Competitive Design Alternatives Report

923 - 935 Bourke Street, Waterloo

Submitted to City of Sydney Council
on behalf of Woolworths Group

Figure 2 Furtado Sullivan Photomontages

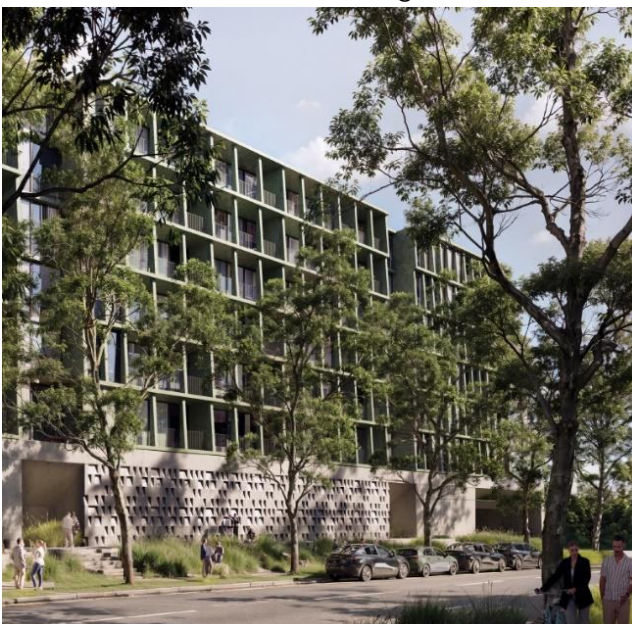
The Furtado Sullivan scheme was appreciated for its contemporary design and refined architectural expression. The Selection Panel praised Furtado Sullivan for a thoroughly considered and well resolved design that successfully integrated the multiple uses and elements on the site.

The Selection Panel praised the scheme's clever positioning of circulation spaces that achieved good access to light and air and the clarity of the apartment design principles. The massing approach created interest along the through site link and provided relief to various frontages. The scheme was praised for its pragmatic response to the Tree Protection Zone constraints which were resolved without becoming the dominant architectural concept. The opportunity for a multi-function room on each level was a positive gesture and the thoughtfulness of the alternative apartment concepts were noted by the panel.

The proposed commercial building was well articulated and held the corner in an effective manner, clearly delineating itself from the residential components, while retaining a shared design vocabulary with the other buildings. The building presented a recognisable commercial identity. The resolution of the Bourke Street frontage was considered well activated and presented a unique streetscape character.

The scheme was specifically recognised for the proposed function and interface of the residential and retail components. The retail arrangements were considered effective, however further resolution around the location of the escalators and travelators was required. Whilst the centrality of the courtyard was appreciated, acoustic attenuation from McEvoy Street may require further design refinement.

Despite the scheme's strong architectural integrity, it was noted that the proposed architectural language and rectangular grid spanning the residential component was reasonably intense in character and possibly more suited to a commercial building. While the architectural expression was rigorous, the Panel considered there may have been further opportunity to ground it in the location through interpretive architectural means. Further refinements to the ground floor were required to avoid a blank wall treatment of Young Street.

Figure 3 Koichi Takada Photomontages

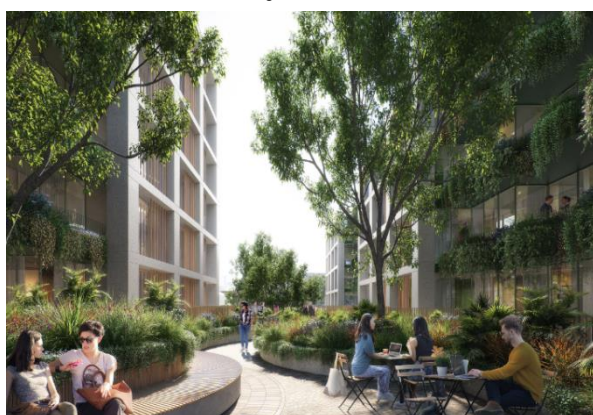
The Selection Panel commended Koichi Takada Architect's intentional and strong design informed by the existing tree canopy. The proposed landscaping and greening strategy were considered strong elements of the scheme and the circular motifs and Connecting with Country through the water treatment was identified as important aspects of the scheme.

The scheme proposed scalloped facades to the internal courtyard in response to the proposed canopy trees, which the Panel considered a successful design gesture that responds to and thoughtfully celebrates the trees of the site – existing and proposed. The proposed concrete and terrazzo facade grid design was also considered a strong contrast to the existing context, presenting a unique streetscape contribution.

The scheme featured a well considered and functional retail plan that was well integrated with the other components of the development. Overall, the scheme was designed in an efficient manner, featuring regular floorplates with potential to accommodate flexible dwelling typologies.

The Selection Panel considered however, that further resolution to ensure solar access cross ventilation compliance with the Apartment Design Guide was required. Through the addition of a fifth core, the multiple core configuration presented an opportunity to provide additional cross-ventilation, while optimising north facing apartments and reducing nil-solar apartments to an acceptable minimum. The extended residential corridors and lobby entry locations presented opportunities for further refinement to enhance resident experience.

While the Selection Panel considered the public plaza with the suspended circular wetland a unique and effective landmark element of the scheme, it also inherently created direct openness to the McEvoy Street which raised acoustic concerns.

The design of the separate vehicular access points along McEvoy Street was commended for providing a functionally sound intervention for traffic safety, however further resolution in regards to the loading and direct to direct to boot parking spaces was required to provide an efficient and user-friendly configuration.
